Gowers Street, Rochdale

Design and Access
Statement - Addendum

Rev P02

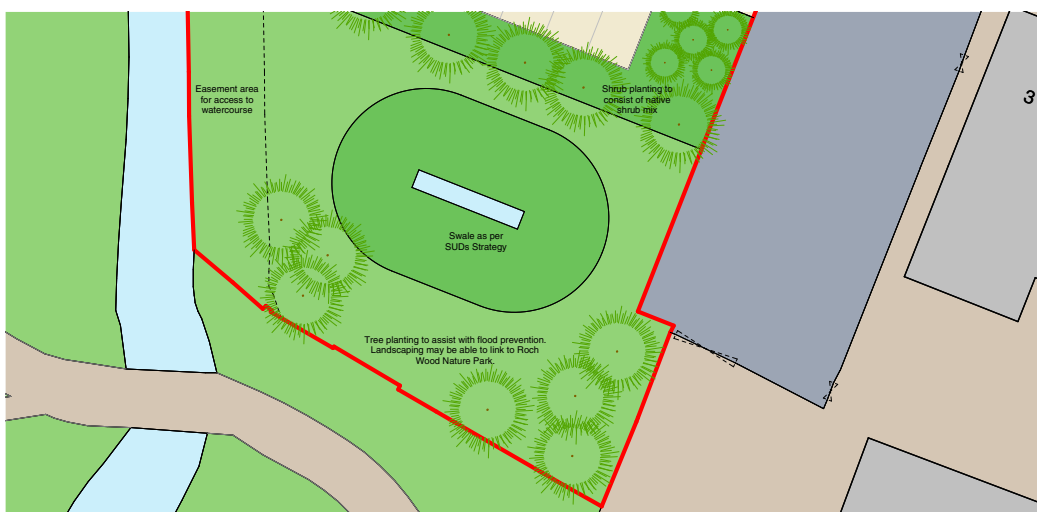
The amended site plan now also incorporates the swale proposed within the SUDs report, the easement area required to Hey Brook and some minor changes to the car parking layout and access to the dwellings to improve functionality.

The Drainage Officer requested that the two points within the JBA Addendum to the Drainage Strategy be provided at Discharge of Drainage Conditions stage. These are the permeable surfacing to the car parking area and the surface water attenuation basin which have now both been included on the site plan.

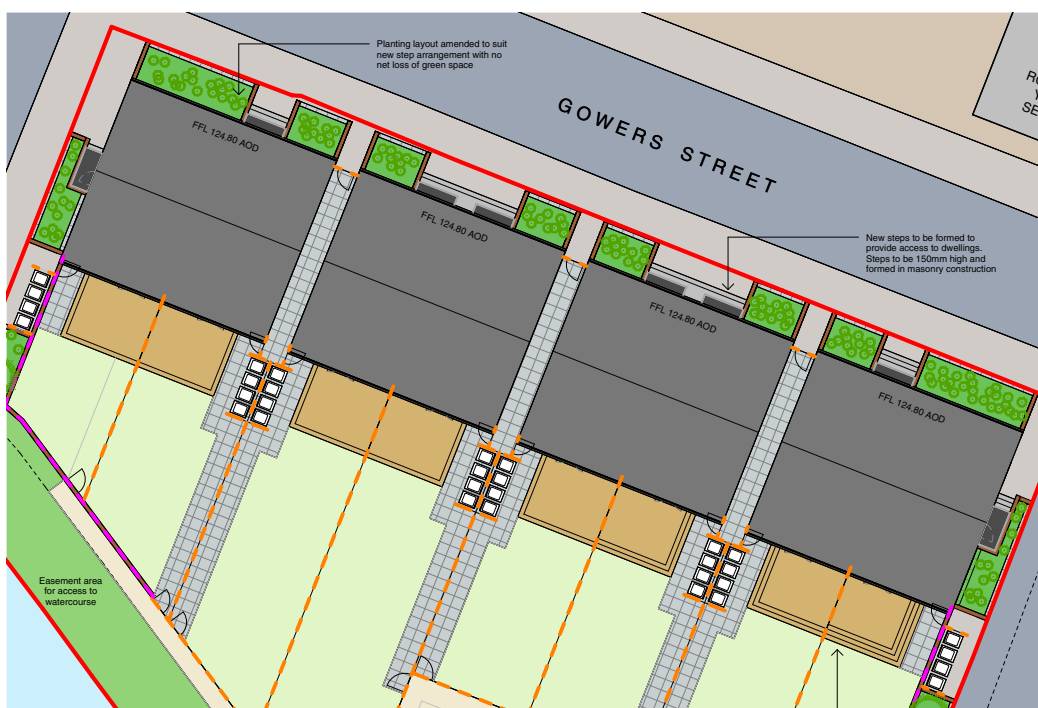
Based on the conclusions of the Flood Risk Assessment by JBA Consulting version P03 dated March 2021, it was determined that FFLs should be elevated above the '1% AEP + 70% increase in flow' level which is 124.34m AOD.

The revised FFLs for the houses are now set at 124.80m AOD which allows for a 460mm freeboard to the Flood Zone 2 level.

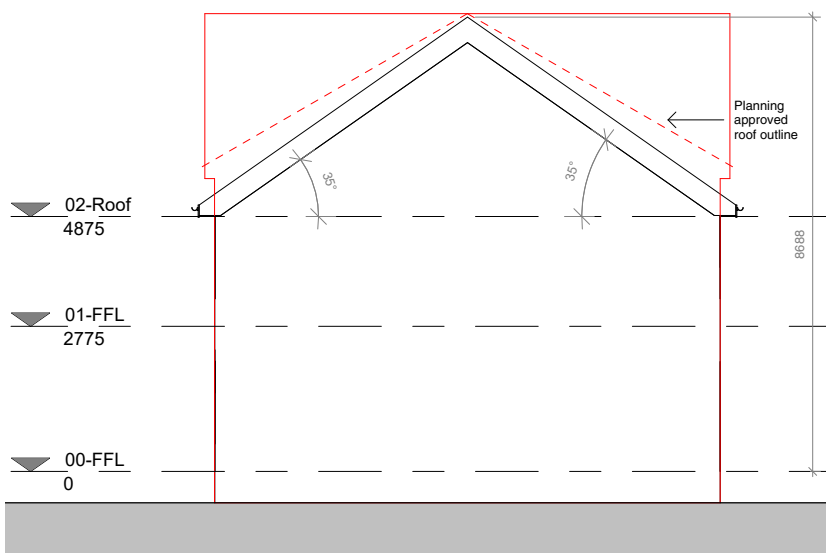
In order to maximise the roof area available for solar panels in the future, the roofs have been amended to have a 35degree pitch to the south orientation and the two end plots changed to a gable end.
